Product hierarchy no. *			Part no.	SBU	Type / Description	Customer part no.
SBU	PG	PGU	Type			
02	006	016	0000001543	See list below	Power Entry Module with Filter	5120

Filter cases for front and rear mounting have a new surface treatment process in order to product improvement.

5120					0118.2246	
creation date	created by	release date	released by	notification no.	revision	page
2014-10-23	buechlp	2015-01-20	buechlp	26907	-	1 of 2

Screw versions front-side

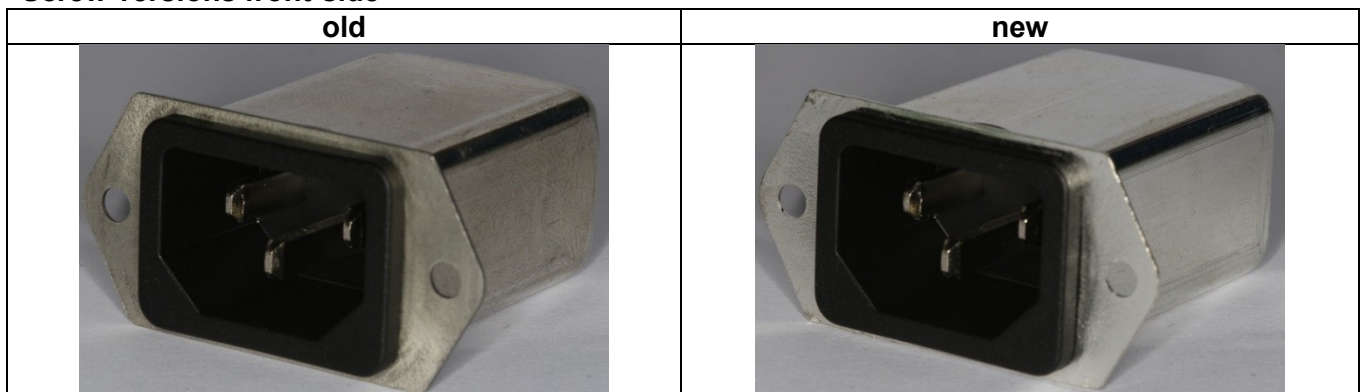
Surface treatment process of filter case has changed with no change of surface material.

Form:	No	No change to form but more shiny surface
Fit:	No	There are no dimensional changes
Function:	Yes	Improved resistance against corrosion
Production Site:	No	There is no change of the production site
Product Label:	No	No change to product label
Customer action	No	Notification only
